# HISTORIC AND DESIGN REVIEW COMMISSION

#### October 20, 2021

HDRC CASE NO:	2021-474
ADDRESS:	244 W HOUSTON ST
LEGAL DESCRIPTION:	NCB 122 BLK LOT 19
ZONING:	D, H, RIO-7B
CITY COUNCIL DIST.:	1
DISTRICT:	Main/Military Plaza Historic District
APPLICANT:	Alan Neff/36square
<b>OWNER:</b>	244 W HOUSTON LLC
TYPE OF WORK:	Exterior alterations, storefront installation, canopy installation, patio seating
	installation, painting, signage, mural installation
<b>APPLICATION RECEIVED:</b>	September 21, 2021
60-DAY REVIEW:	Not applicable due to City Council Emergency Orders
CASE MANAGER:	Edward Hall

**03** section a - through storefront scale 1-1/2" = 1'-0"

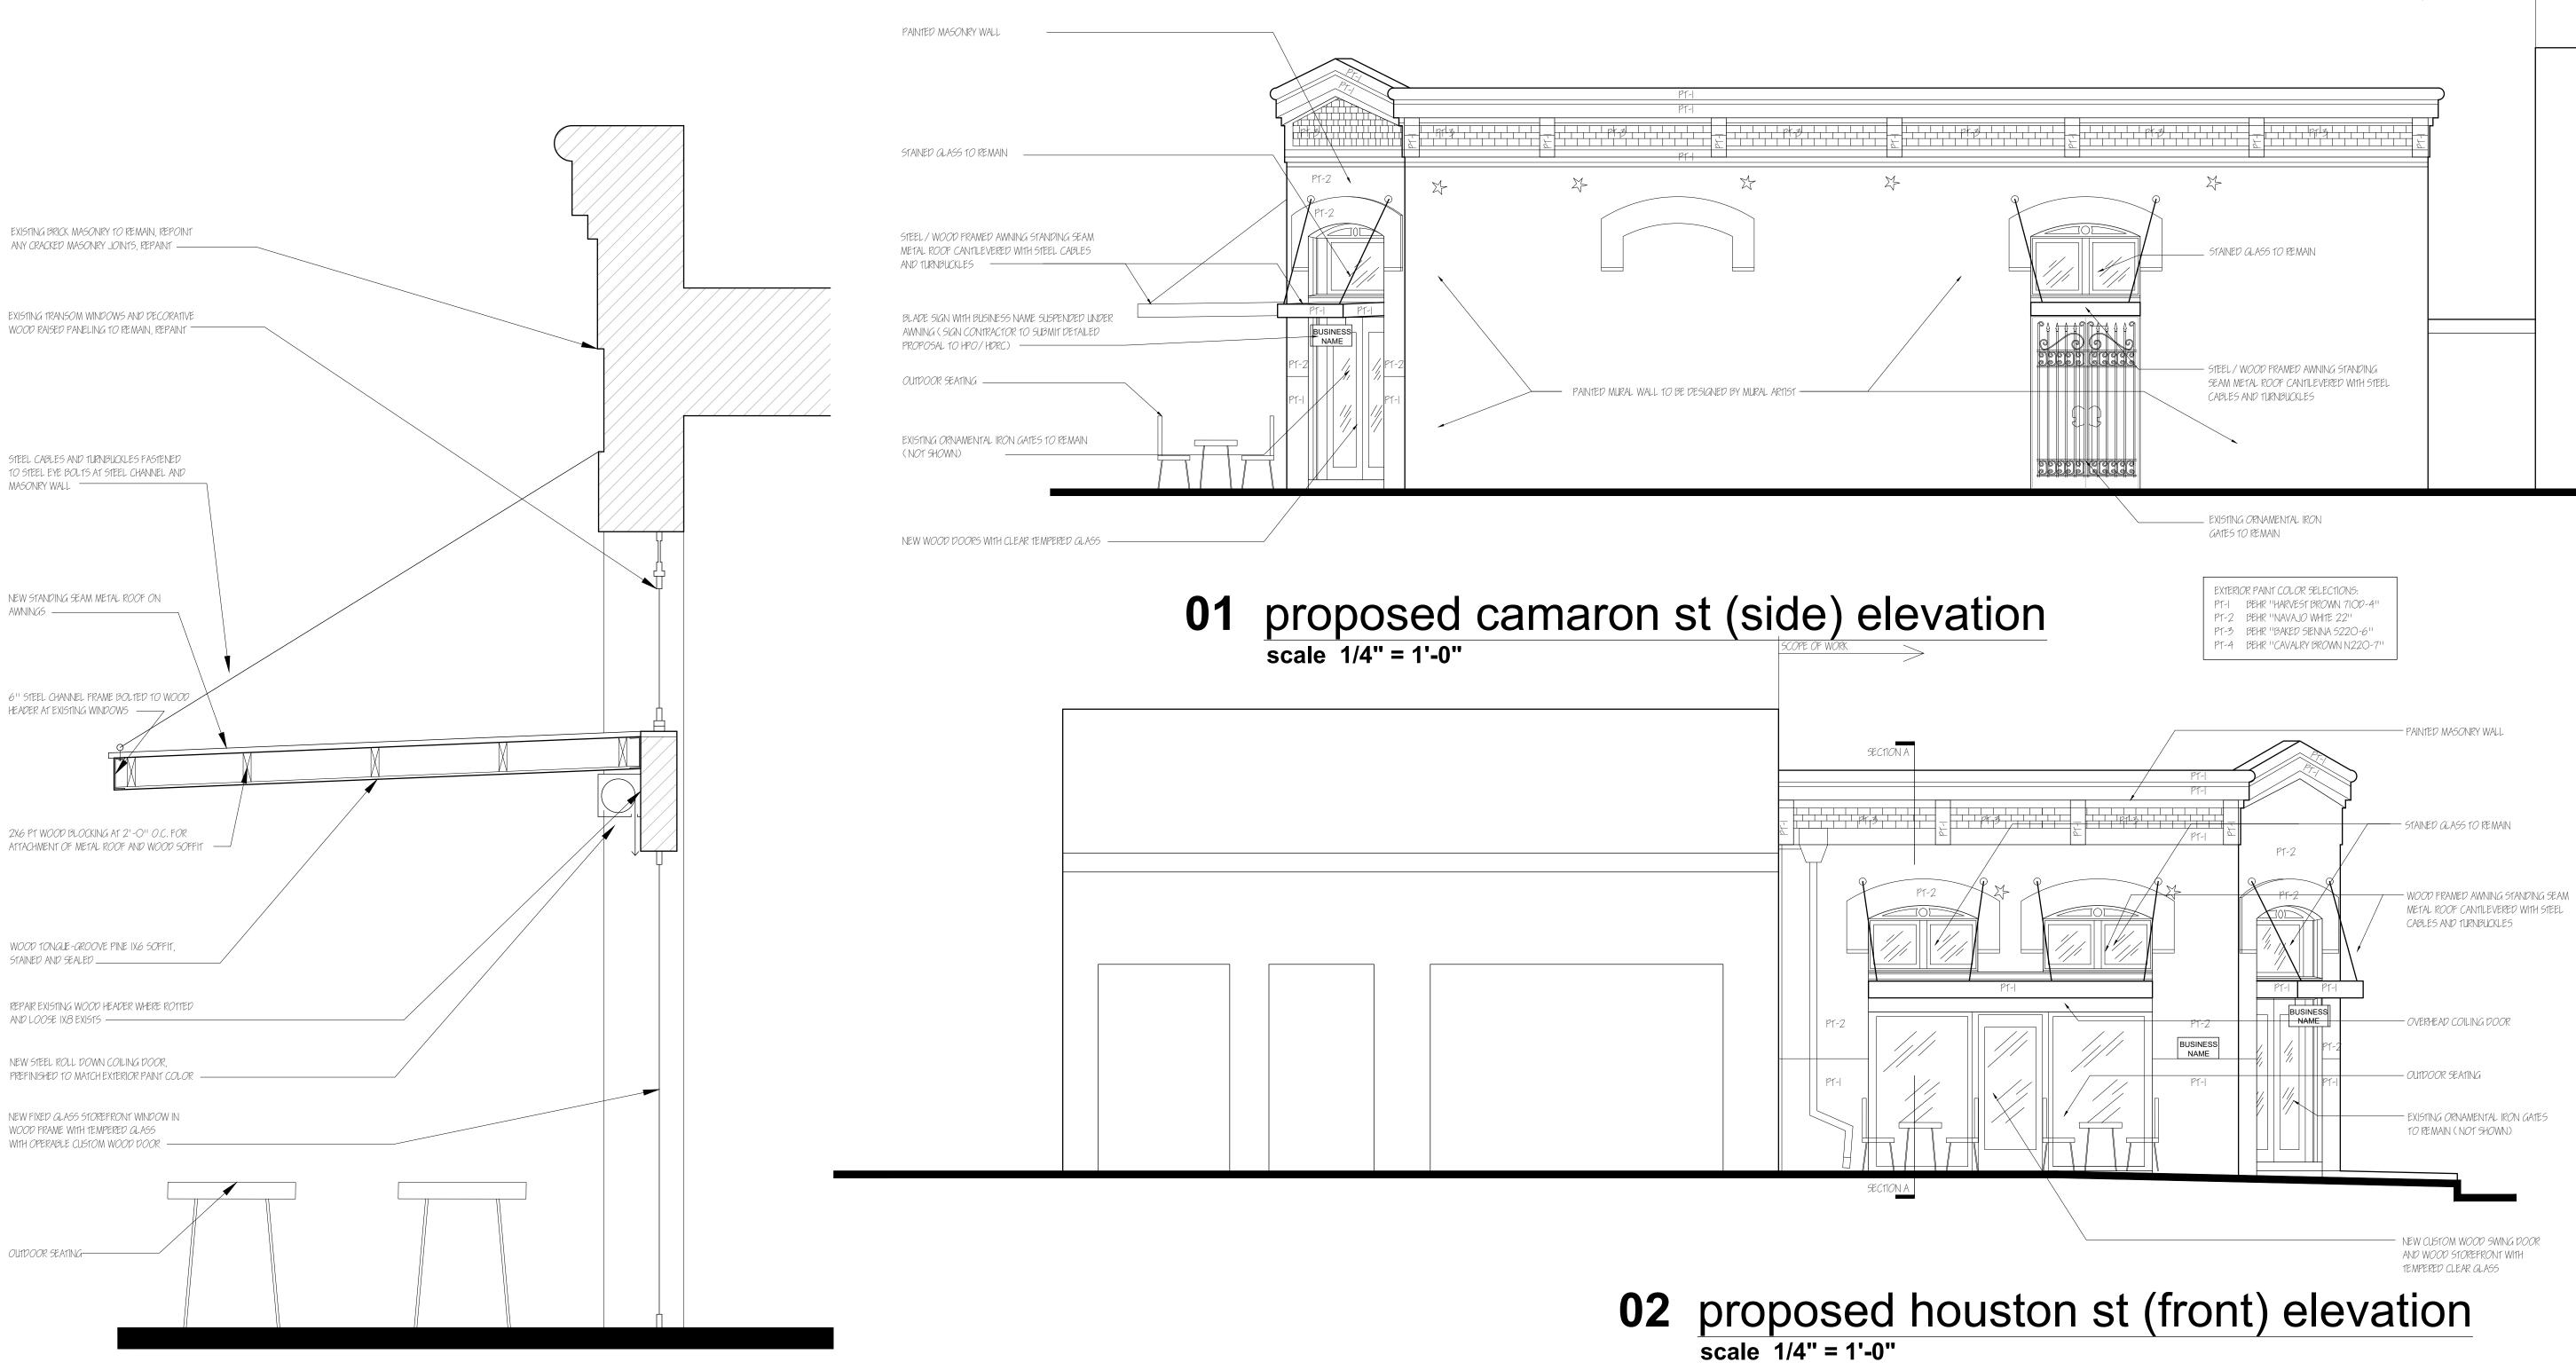
- d. STOREFRONT SYSTEM The applicant has proposed to install a new wood storefront system on W Houston Street. The original façade configuration was modified for a recessed entrance, which has been modified to feature an inappropriate storefront system that was installed without approval. The Guidelines for Exterior Maintenance and Alterations 10.B.ii. note that non-historic facades should be returned to their original design based on photographic evidence. When evidence is not available, the scale, design, materials, color and texture of new materials should be compatible with those of the historic façade. Generally, staff finds the proposed

storefront system to be appropriate; however, staff finds that the storefront system should feature a pony wall of at least two feet in height, consistent with historic examples found in the immediate vicinity.

- 3. Staff recommends approval of item #3, the installation of a wood storefront system.
- 4. Staff recommends approval of item #4, modifications to the existing ornamental gate with the stipulation that the outward swinging gates to do not impact pedestrian traffic or ADA access within the public right of way.
